Request for Quotation

RFQ NUMBER
PTR07028

LINE	QUANTITY	UOP	CAT. NO.	ITEM NUMBER	UNIT PRICE	AMOUNT
ADDENDUM NO.3						
RESPONSES AND CLARIFICATIONS FROM THE REQUEST FOR APPROVED EQUALS.						
PER THE ATTACHED						
BID OPENING DATE AND TIME REMAINS 04/18/07 @1:30 P.M.						
NO OTHER CHANGES						
0001		EA		557-05		
	138"	WHEELBASE	NARROW	BODY CUTAWAYS WITH A/C		
***** THIS IS THE END OF RFQ PTR07028 ***** TOTAL:

RESPONSES TO REQUEST FOR APPROVED EQUALS
PTR07028

DATE: 2/13/07 TITLE: 2/3 W/C PASS 138 WB FORD CUTAWAY

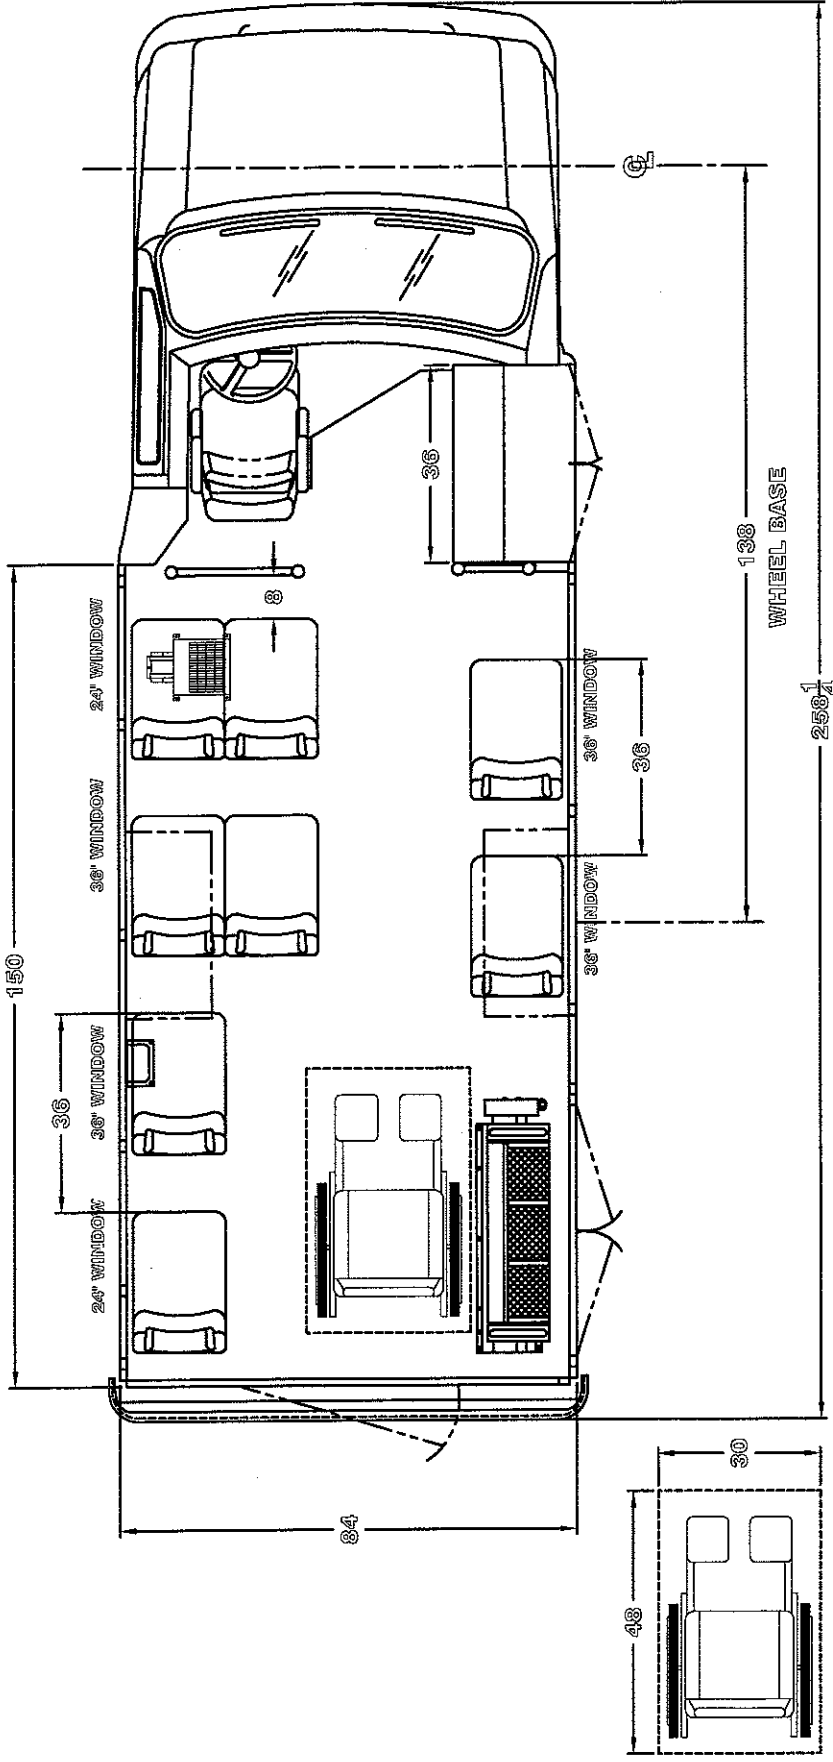
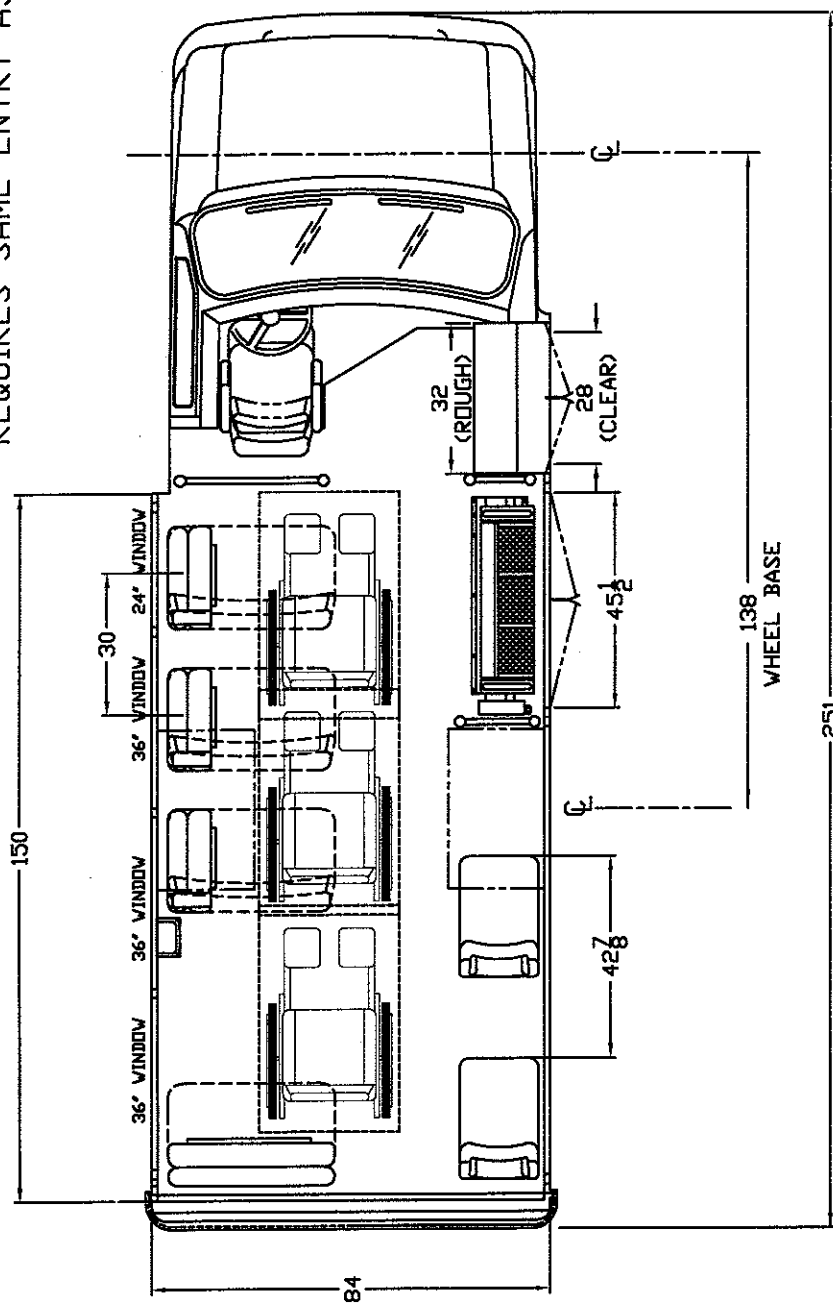
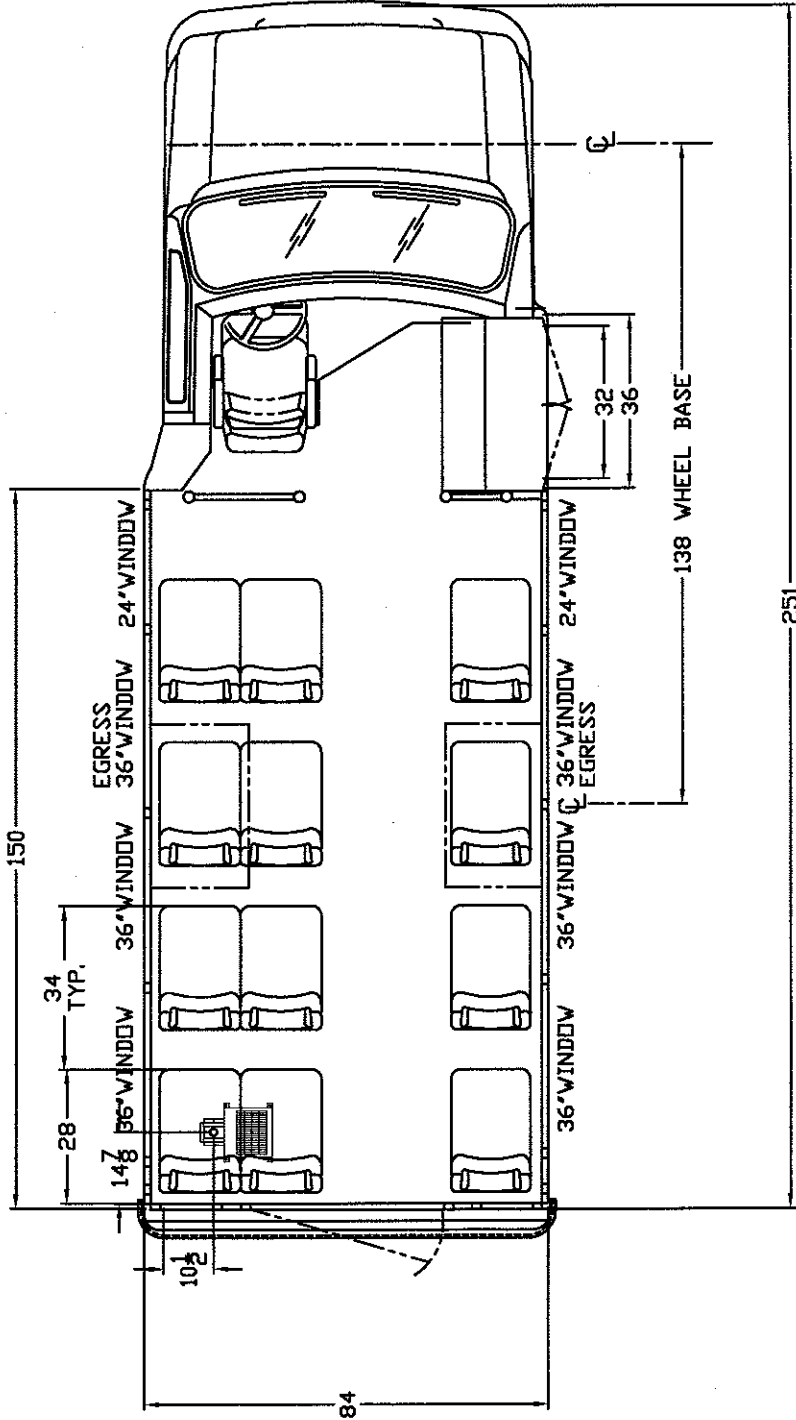
- Part 2, section 8.4.1
Current specification does not require a raised floor that will ensure no intrusions into the bus body compartment. Please clarify if a raised floor is required. If not will the alternate floorplan as submitted by StarCraft be acceptable? See enclosures 1-4.

It is unclear from your specifications as to whether you want a raised flat floor or not. The floorplans released with your specifications suggest a flat floor with no wheel well intrusions. Please review alternate floorplans submitted. We will not be able to meet 80”

clear height requirement with an interior flat floor. Our standard interior height is only 76" to begin with. See literature.

Seating requirements as specified (for 3 point seats) will result in an overweight determination for the 12 passenger. Will WVDPT accept a 158/159" wheelbase vehicle to ensure that GVWR can be met? Revised floorplans will have to be submitted with our bid.

Section 5.2	Approved as long as it is Ford's standard dual batteries.
Section 6.2	It is up to the bidder to supply this information.
Section 8.2.1	Denied
Section 8.4.2	Approved
Section 8.6	Bidder may use standard rub rails.
Section 11.1	Approved
Section 15	Mudflaps at each wheel location. Must be rubber.
Section 19.2.2	WVDPT will send via-e-mail.
Section 2.2.1	Bidder must contact service locations and supply with bid.
Floorplans	Approved
Floorplans	Approved
